Keystone RV Company

SAFETY ADVISORY # 24-452

Suburban LED Stove Lights

Fig. 1

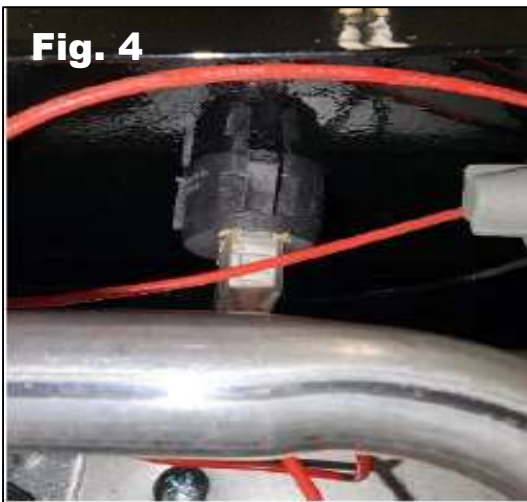
Remove the range main top, by pulling up at the front then set top aside. See Figure 1.

The remedy is to disconnect the 12-volt power to the stove lights, cap incoming wires.
